Master File #: S-2017-002

Incompleteness Response:

PRELIMINARY SUBDIVISION PLANS FOR KEIL GARDENS SUBDIVISION

SHEET TITLE:
COVER SHEET
 G-0.01

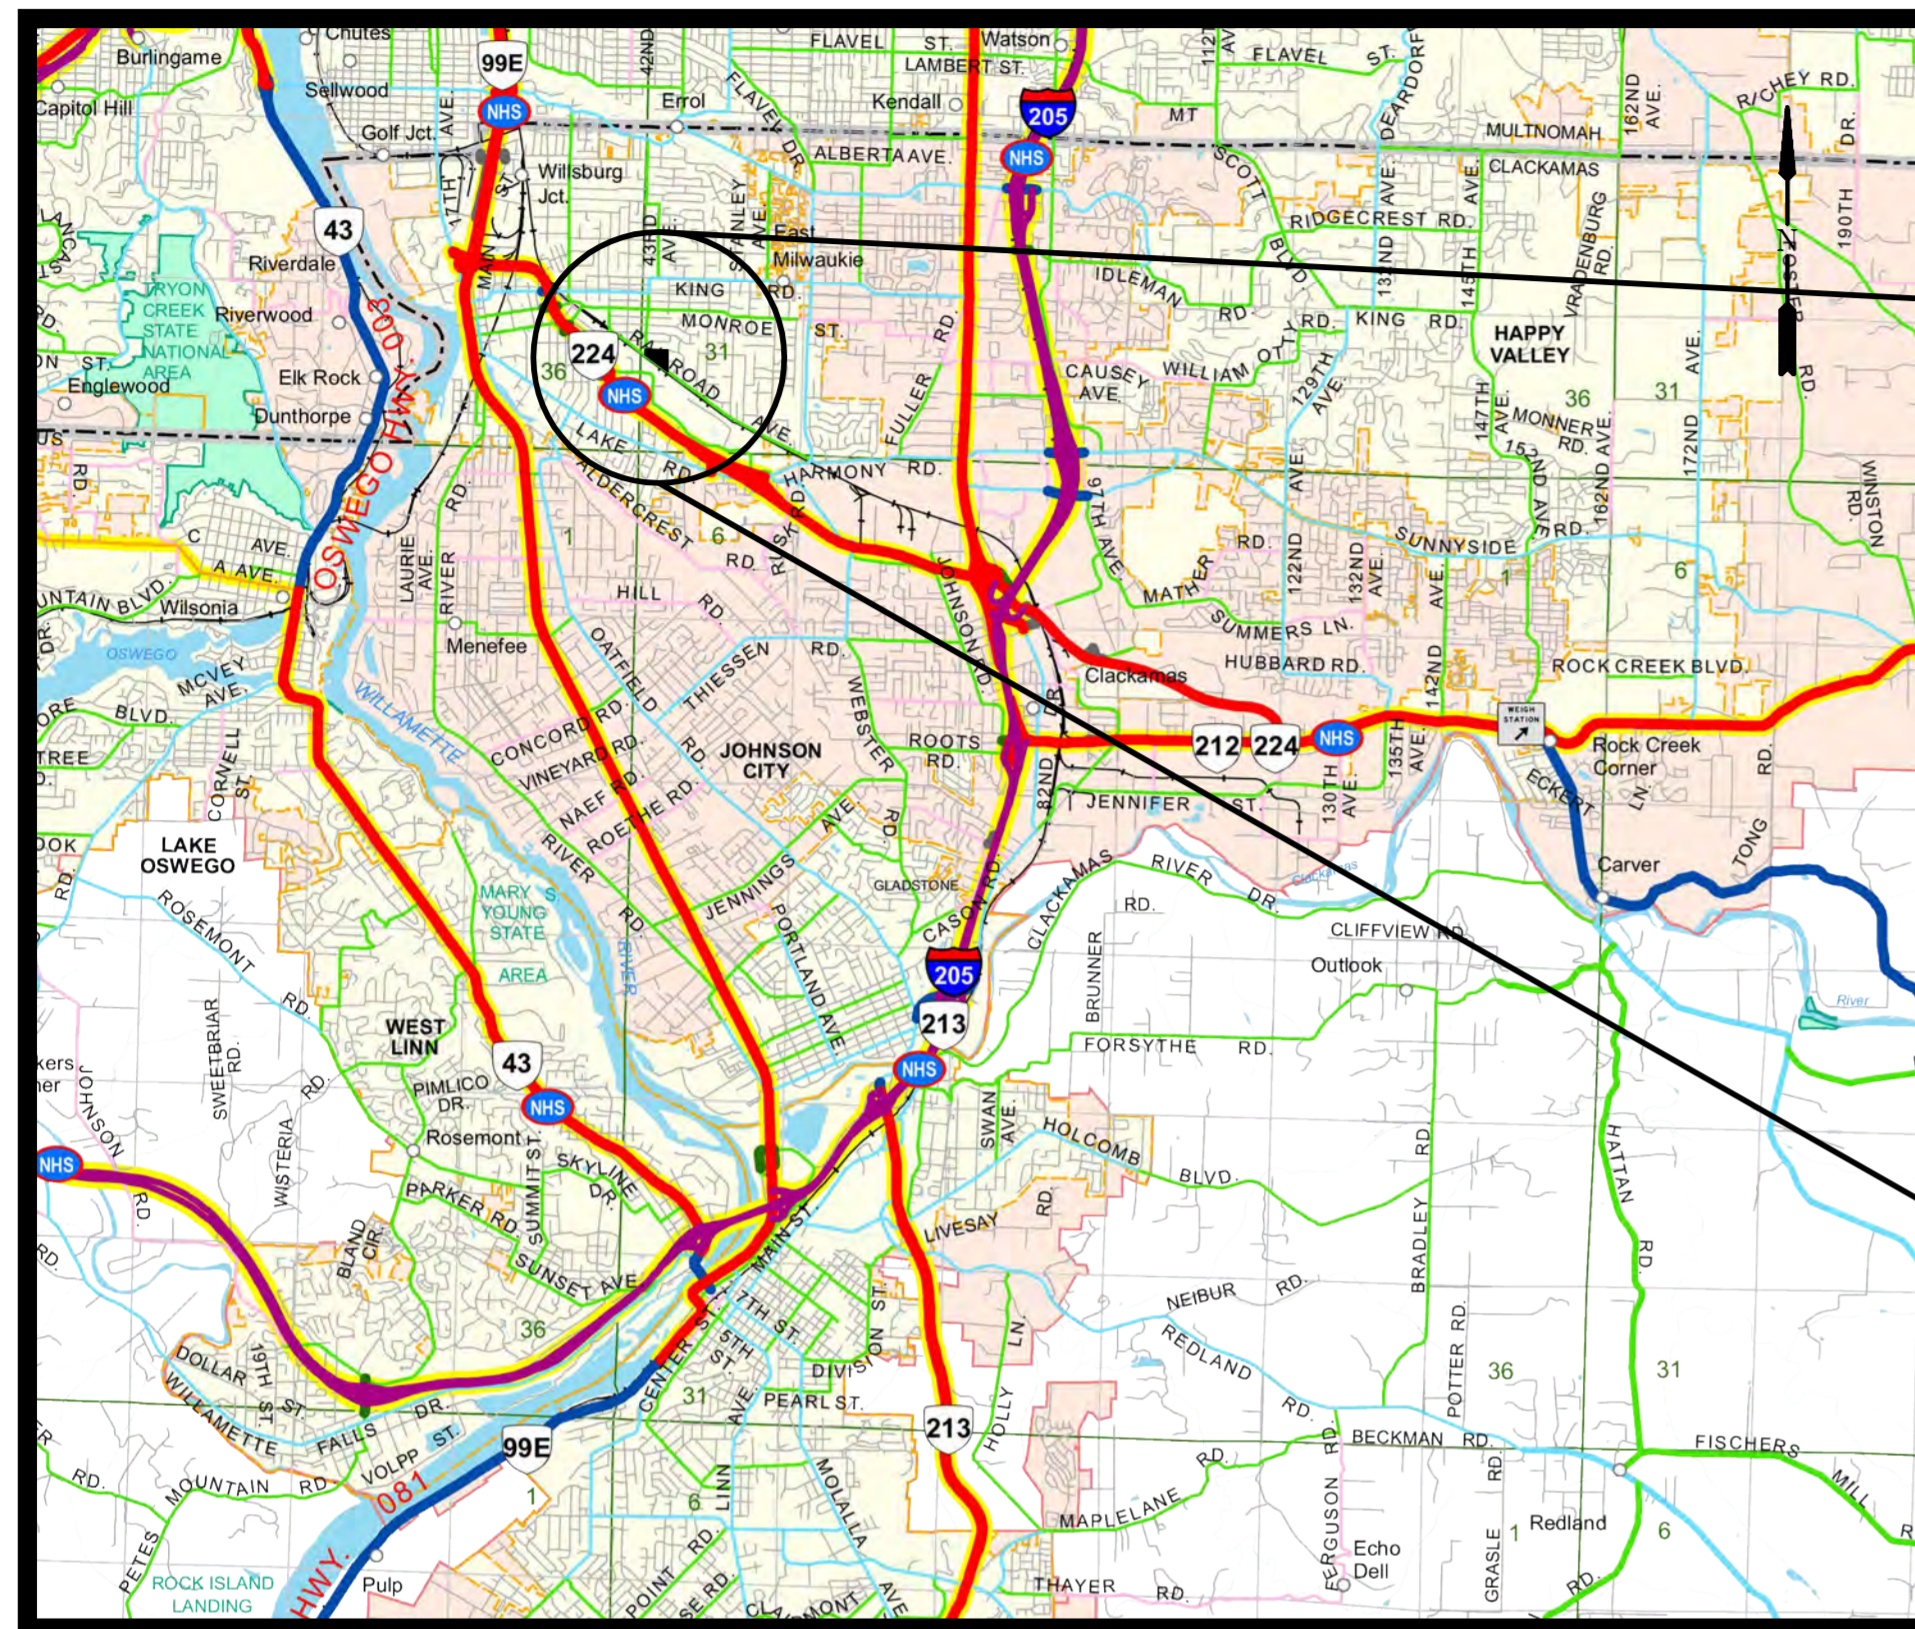
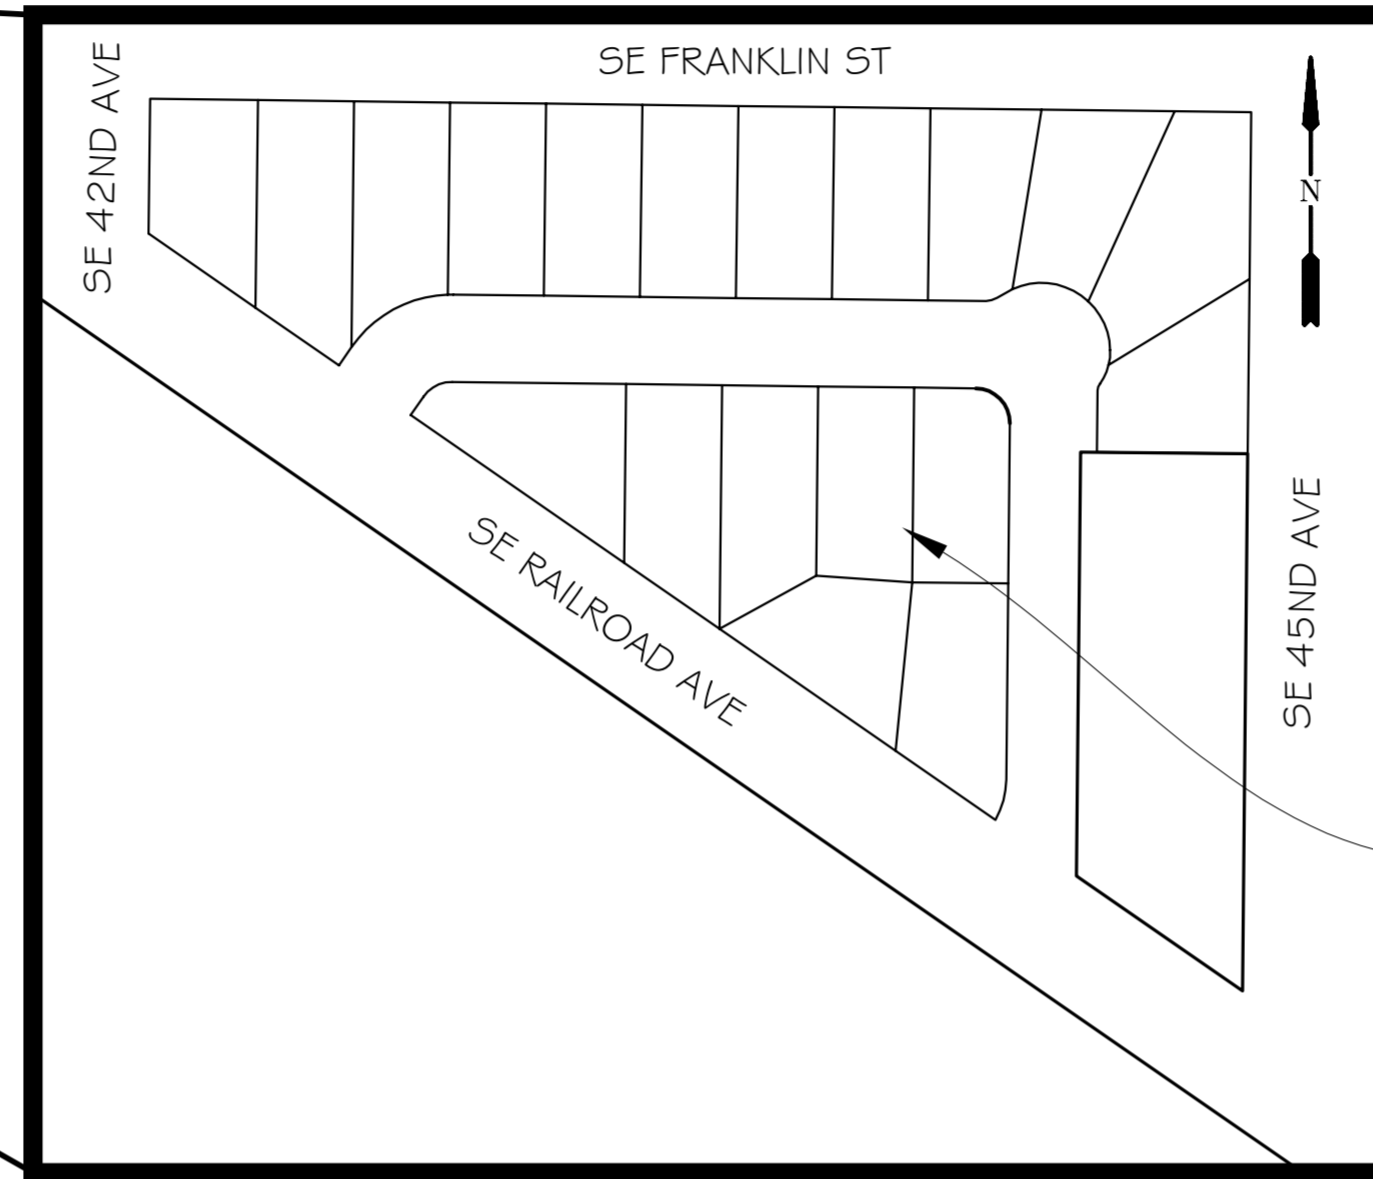
- a. Sheet G-0.01 of the submitted plan set denotes a different property owner than the owner listed on page 1 of the application narrative. Please revise the submittal so that this information is correct and consistent within the application sections.

Comment: The new plan set, and narrative have been appended to reflect the correct ownership of the Tax lots to be developed.

SHEET TITLE:
SITE PLAN
 C-1.03

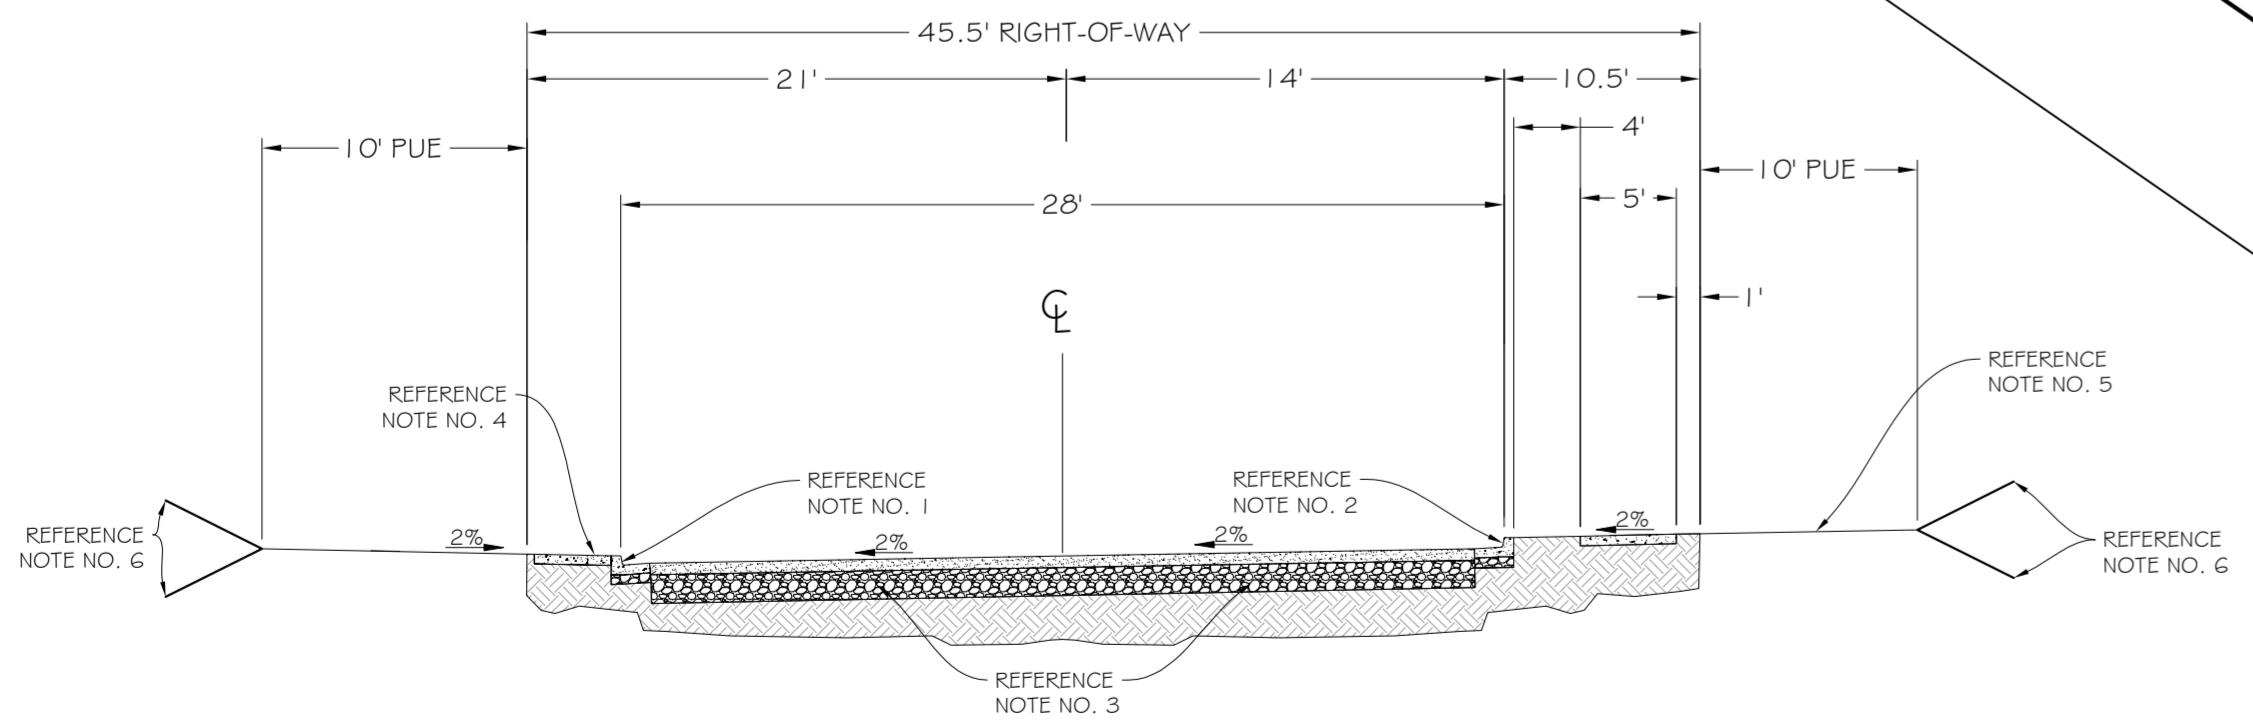
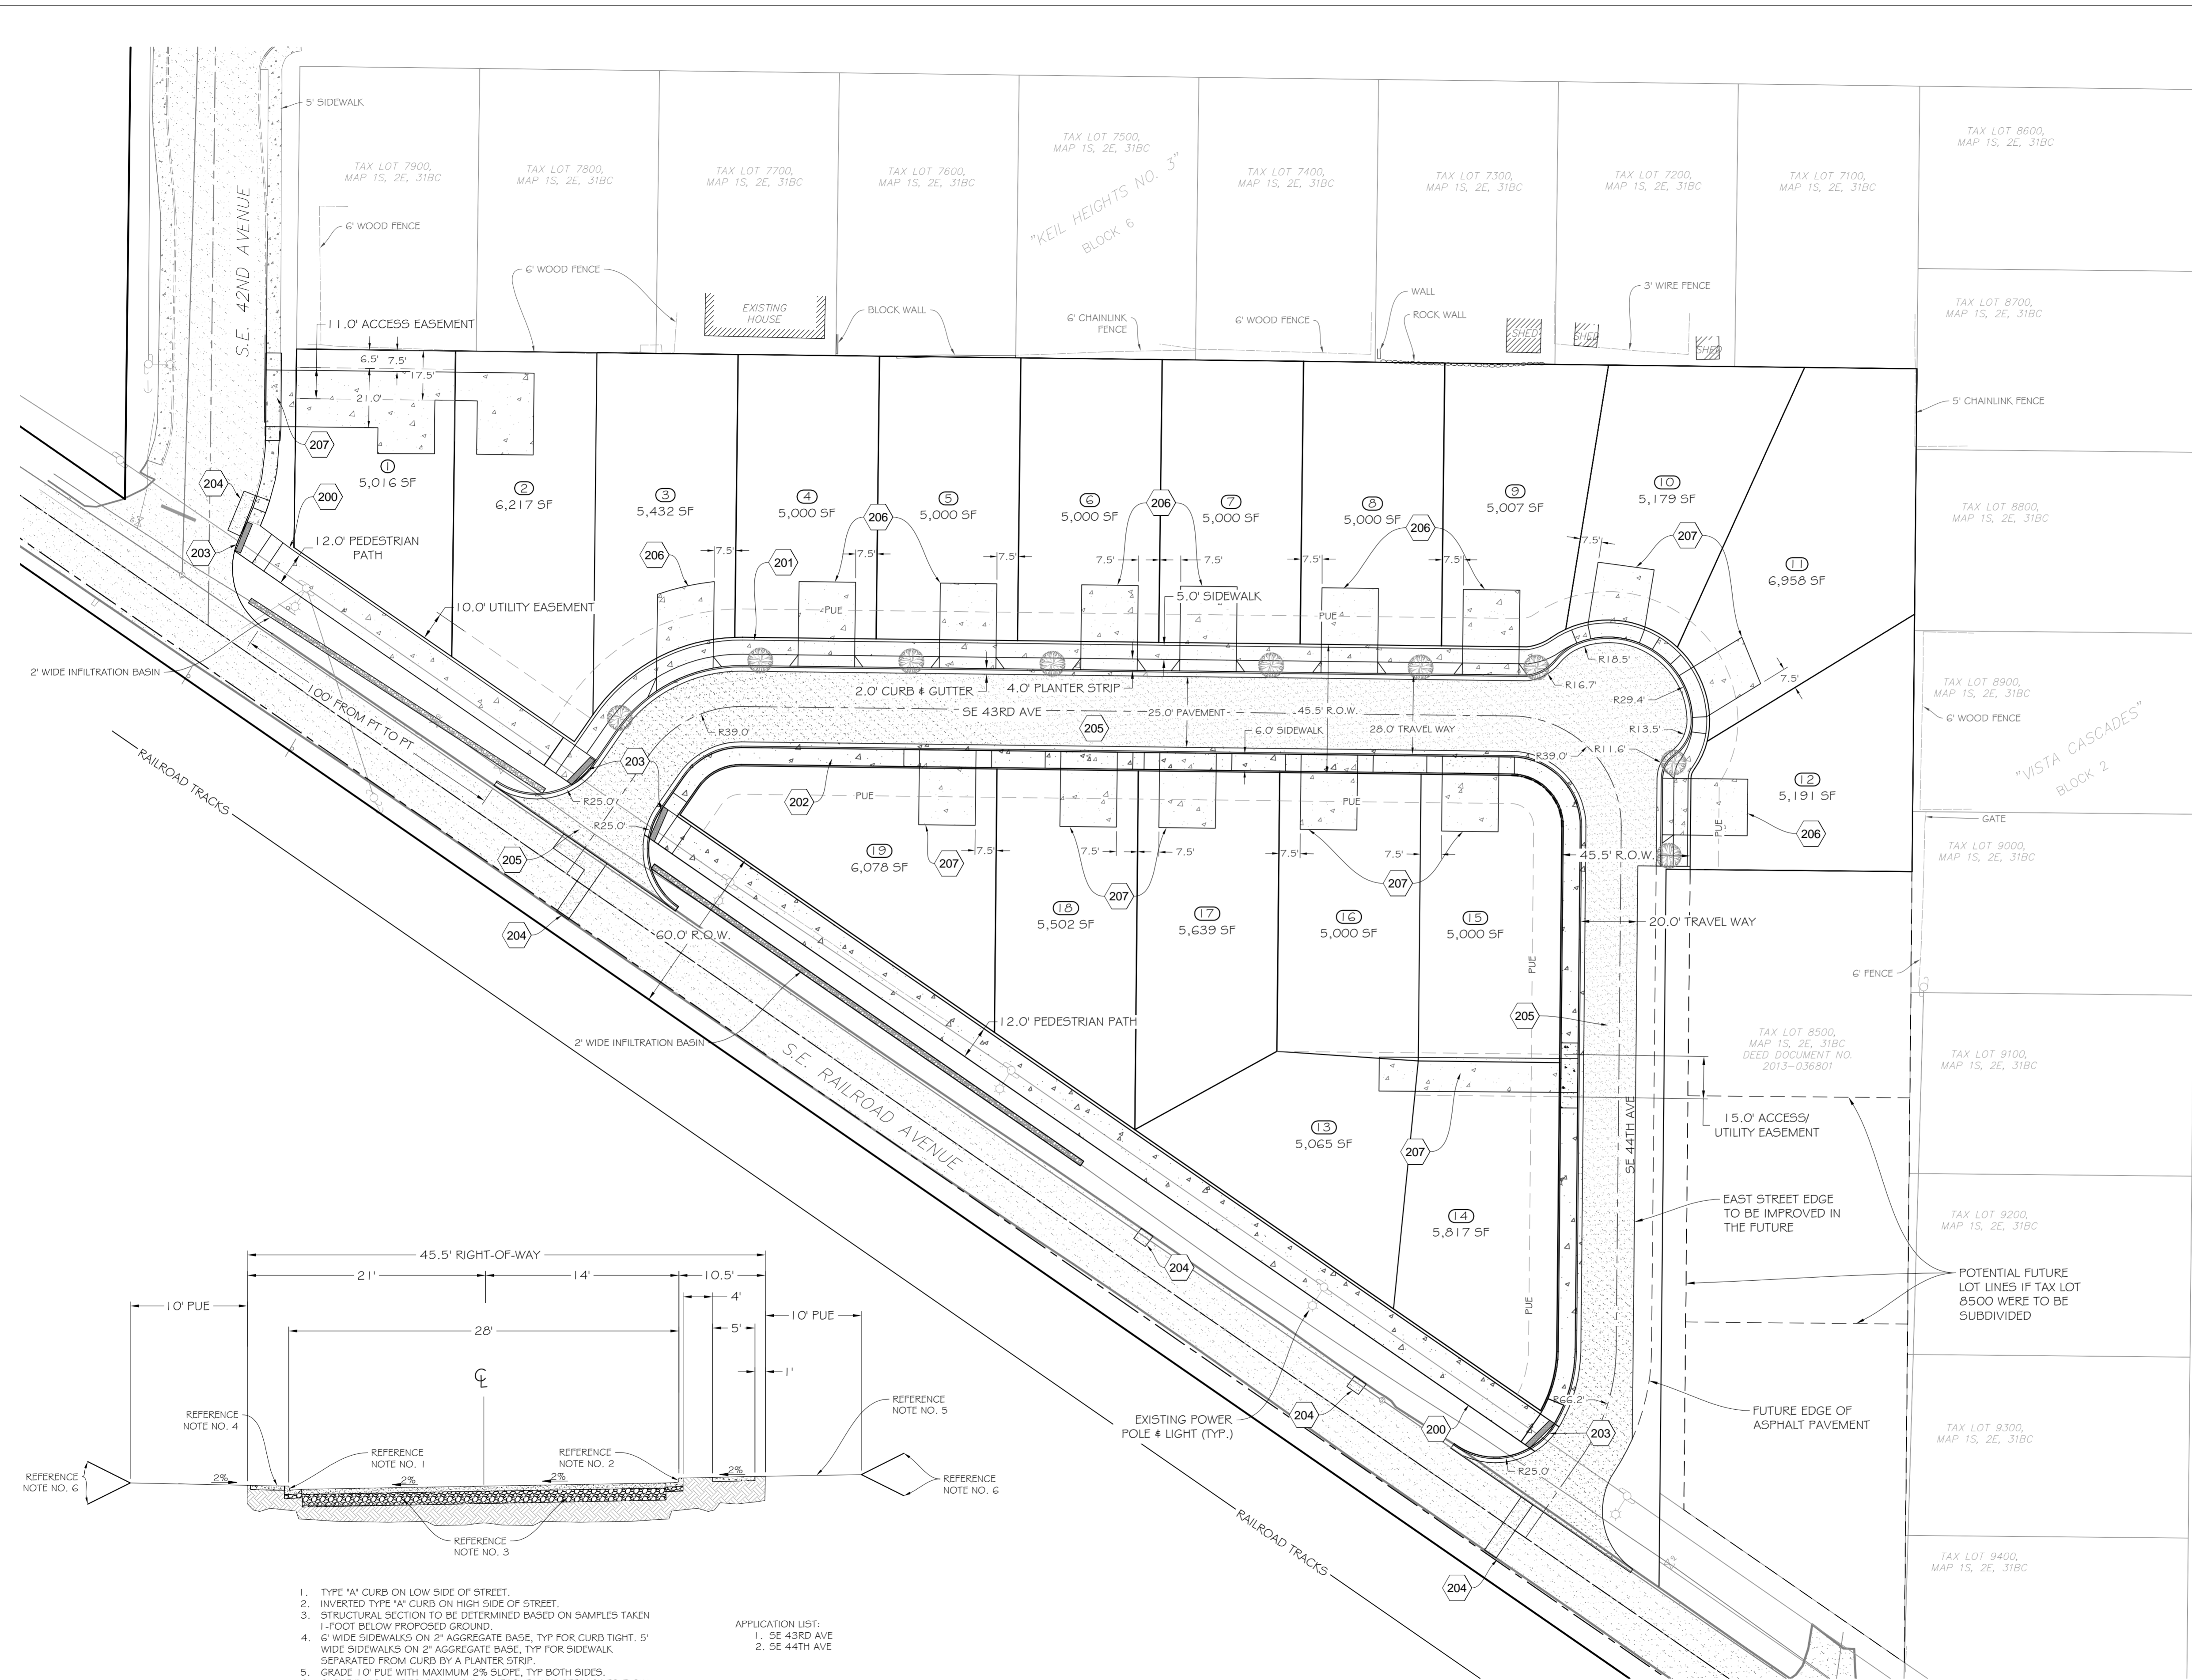
c. As defined in MMC 17.28.040.F, required frontage shall be measured along the street upon which the lot takes access. As shown on Sheet C-1.03, Lot 1, Lot 2, and Lot 13 show access via an

5. Plan Sheet C-1.03 indicates a right-of-way width of 45.5 ft. The sum of the components shown should be 48 ft.

Comment: The City has restricted access to Railroad Avenue. Therefore while several lots front onto Railroad, they are not permitted to take access. The lots meet the dimensional requirements of the zoning, but still require a Type III variance.

Comment: The applicant has requested that the right-of way width be reduced to reflect the removal of the planting strip. Not doing so would defeat the purpose of the request, and would eliminate a lot, and render lot 19 less buildable
